# THE VILLAS AT CLAREMONT RANCH

## GRADING & EROSION CONTROL PLAN

### INTERIM & VERTICAL PHASES

EPC STORMWATER REVIEW COMMENTS  
IN ORANGE BOXES WITH BLACK TEXT

**THE VILLAS AT CLAREMONT RANCH**  
**GRADING & EROSION CONTROL PLAN**  
**INITIAL PHASE (PUDSP)**

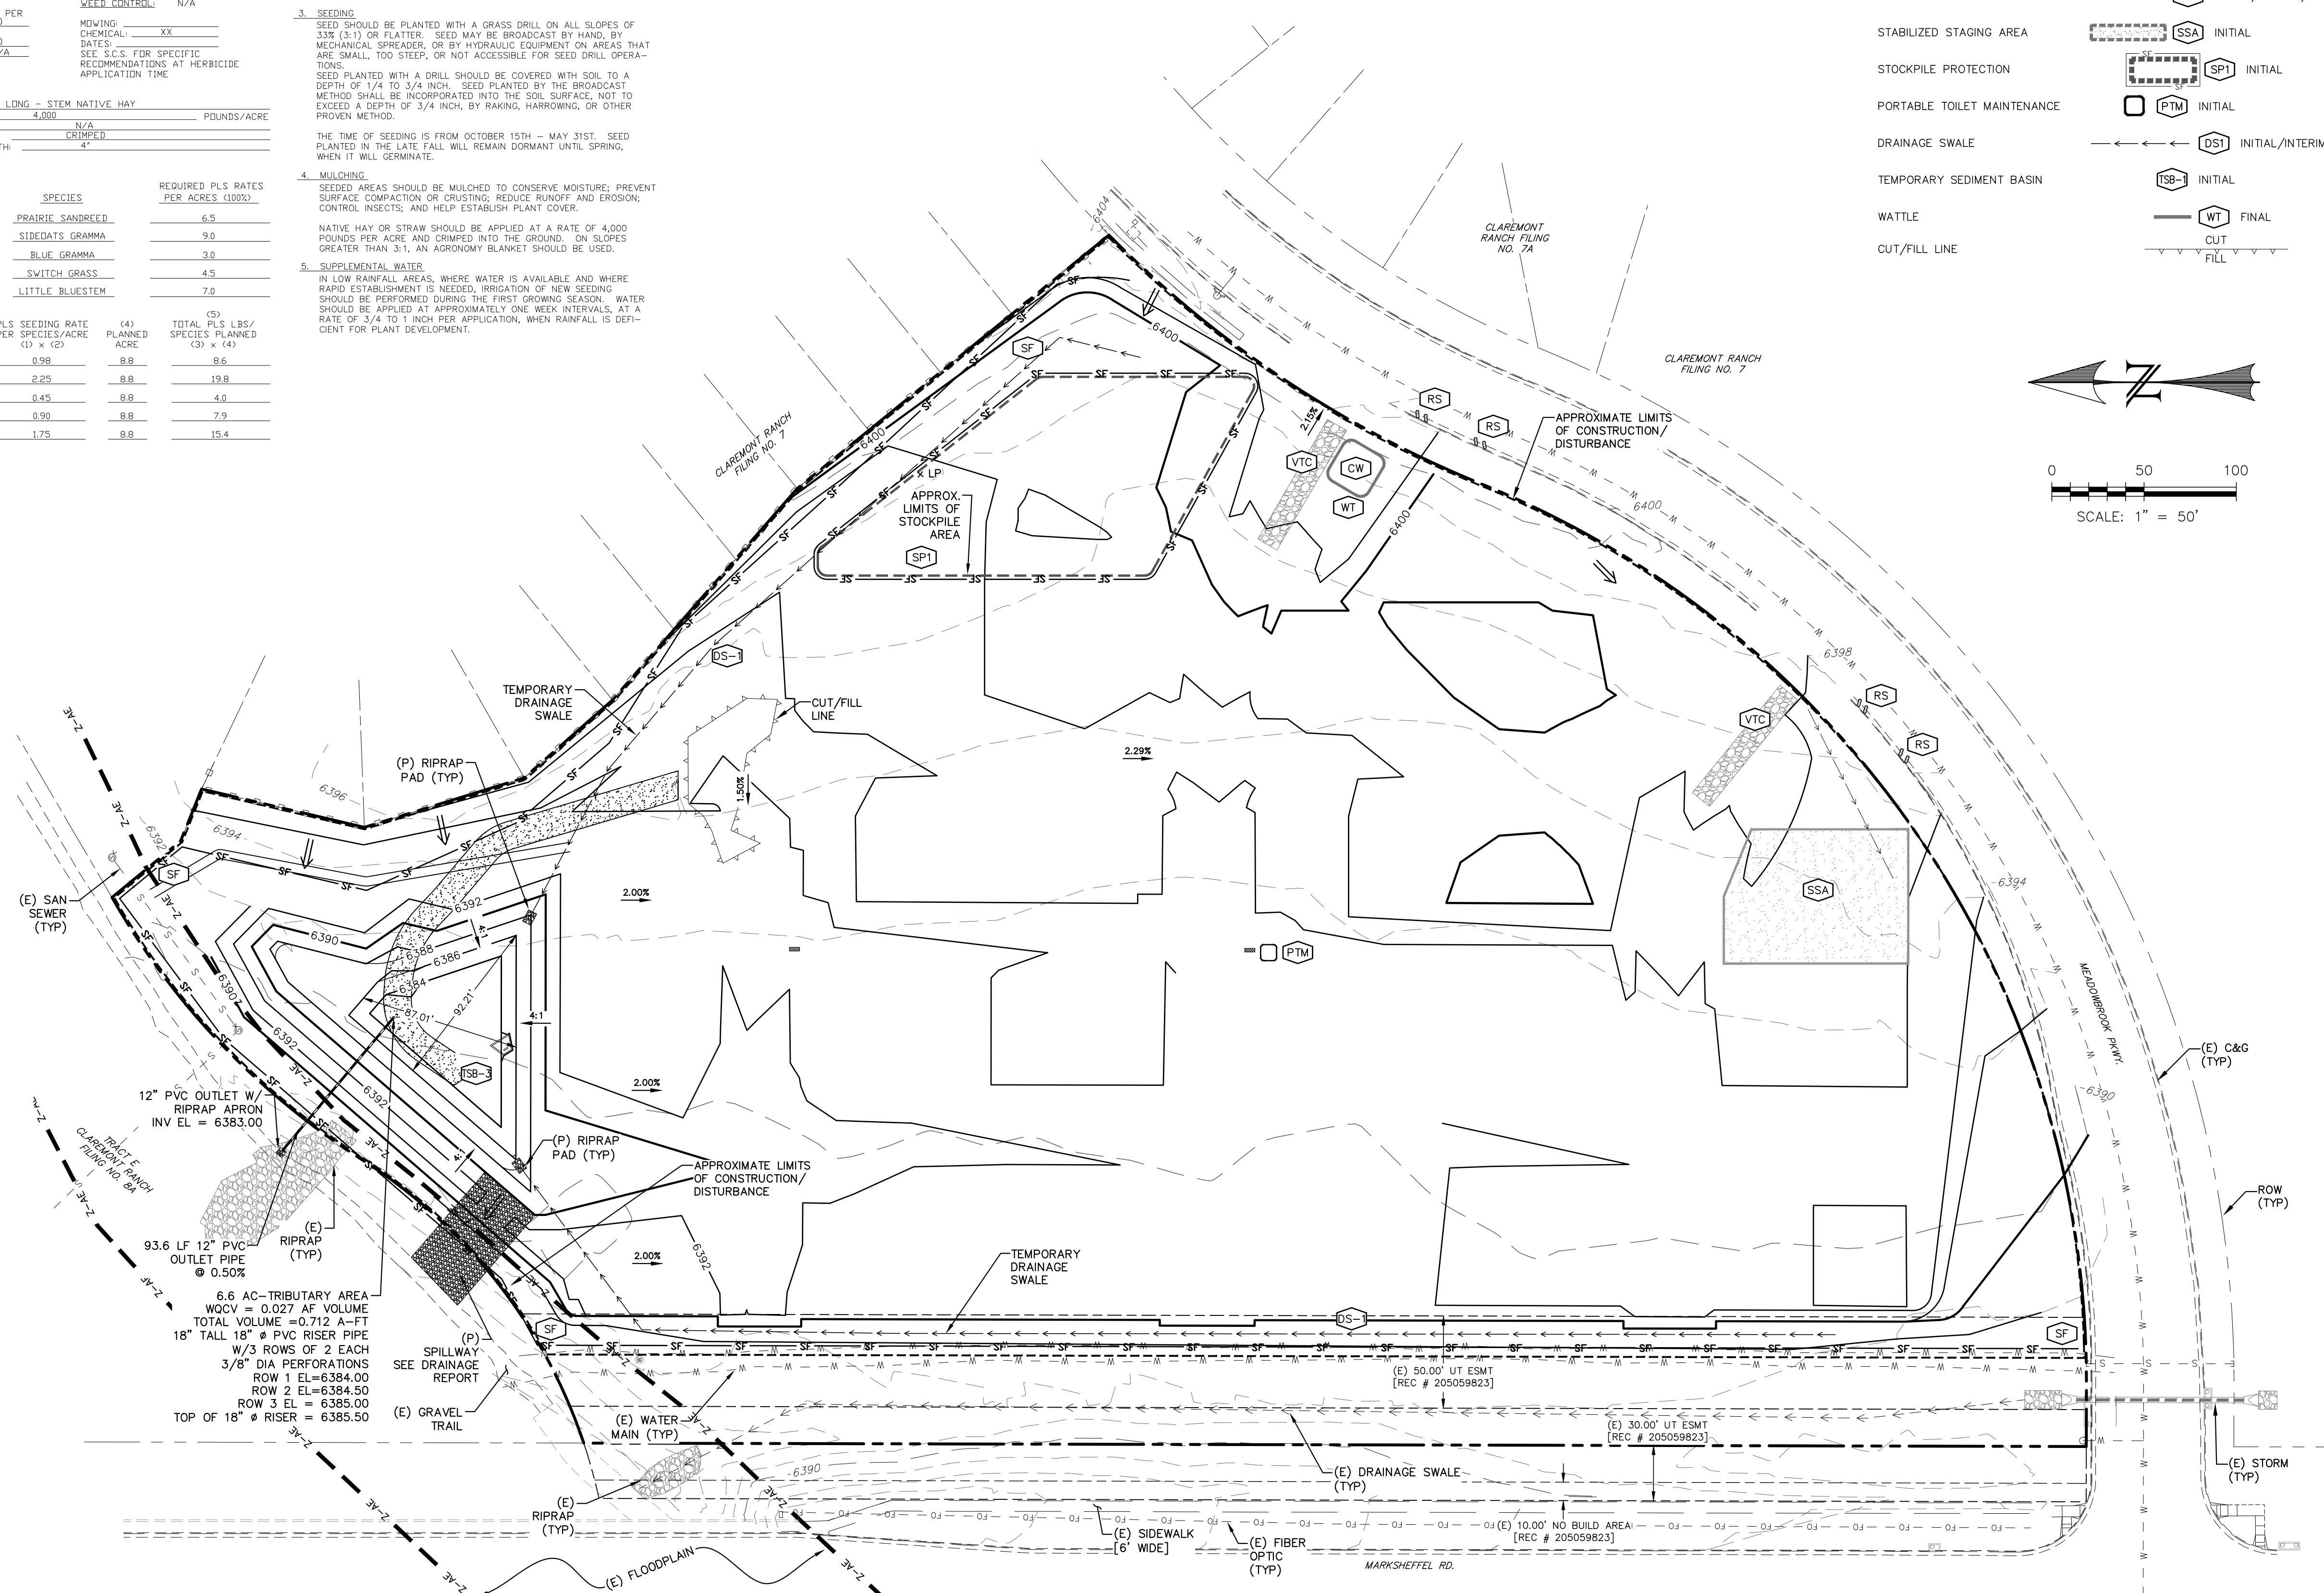
Unresolved:  
Add a note about the existing vegetation condition per GEC Checklist item "1." I see that you added Note #2 above but it needs further info to satisfy this checklist item.

**THE VILLAS AT CLAREMONT RANCH**  
GRADING & EROSION CONTROL PLAN  
INTERIM AND VERTICAL PHASES

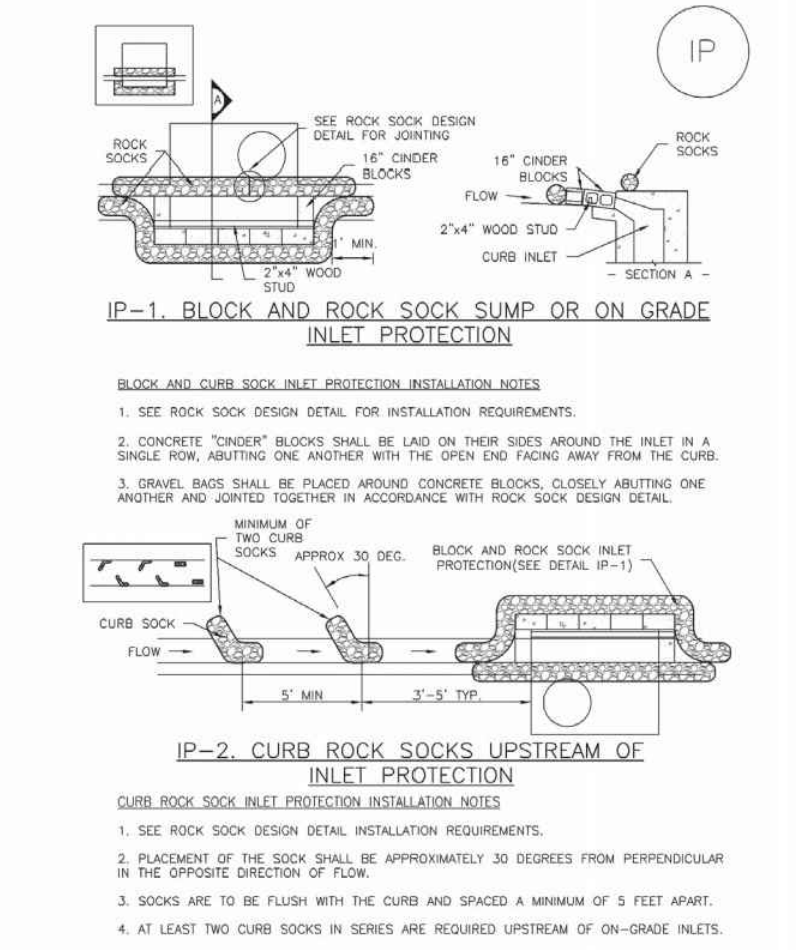
Add a note about what is to happen to the 12' outlet pipe from the TSB? Remove? Cap and abandon in place?

Include all areas of disturbance within the Limits of Disturbance linetype (on this sheet and the next one)
